# Access Compliance Report

## Public Rights-of-Way

### (Curb Ramps)

Intersection ID: 16086	Main Street: HOLLIS_RD	Cross Street: WESTON_ST	Location: NW
ADA ID: 4E45EC588C46	Ramp Type: Directional1	Initial Pass/Fail: Fail	Overall Compliance: No
Codes/Mitigation Info/Possible Solution		Field Measurements/Component Compliance	
Severity Score: 13.75

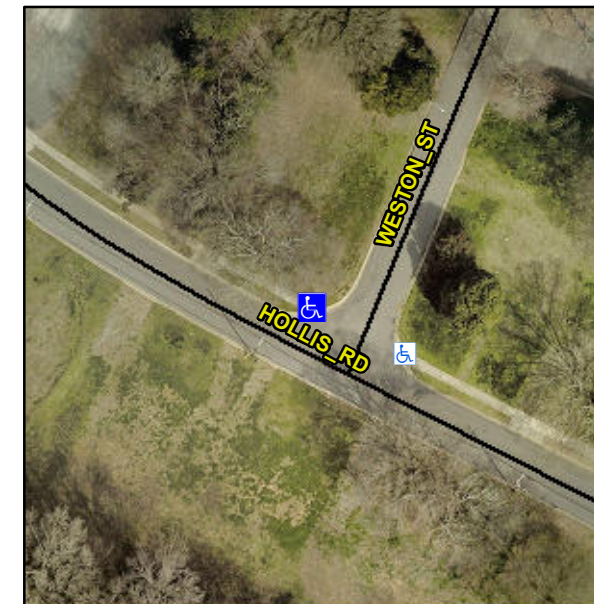
**R304.2.2, R304.5.3**

Compliance	Description	Data	Compliance	Description	Data
N/A	Ramp Length (in)	130.0	N/A	Grade Break?	N/A
Yes	Ramp Width (in)	56.0	N/A	Grade Break Slope (%)	0.0
No	Ramp Slope (%)	10.1	N/A	Grade Break XSlope (%)	0.0
No	Ramp XSlope (%)	3.0			
N/A	Flare Type LT	N/A	N/A	Flare Type RT	N/A
N/A	Flare Slope LT (%)	N/A	N/A	Flare Slope RT (%)	0.0
N/A	Flare Traversable LT?	N/A	N/A	Flare Traversable RT?	N/A
N/A	Landing Length (in)	0.0	N/A	DWS Provided?	N/A
N/A	Landing Width (in)	0.0	N/A	DWS Contrast?	N/A
N/A	Landing Slope (%)	0.0	N/A	DWS Length (in)	N/A
N/A	Landing X Slope (%)	0.0	N/A	DWS Full Width?	N/A
N/A	Landing Curb? (Y/N)	N/A	N/A	DWS Offset LT (in)	N/A
N/A	Shared Landing?	N/A	N/A	DWS Offset RT (in)	N/A
N/A	Gutter Ponding?	0.0	N/A	Gutter Slope (%)	N/A
N/A	Gutter Lip Ht (in)	0.0	N/A	Gutter X Slope (%)	N/A
N/A	Painted X Walk1?	No		Road Slope (%)	1.9
	X Walk 1 Direction	To E		Road X Slope (%)	0.2
	X Walk 1 Width (in)	N/A		Clear Space?	N/A

X Walk 1 Slope (%)	1.9	N/A	Clear Space to XWalk (in)	N/A
	X Walk 1 X Slope (%)	0.2	N/A	Storm Grate/Utility Hazard?	N/A
N/A	Ramp inside XWalk1?	N/A		Storm Grate/Utility Type	
N/A	Any Obstructions?	N/A			N/A
	Obstruction Type		Yes	Surface Condition? (G/P)	Good
			N/A	Curb Slope (%)	21.5

**Remove & Replace Entire Ramp.**
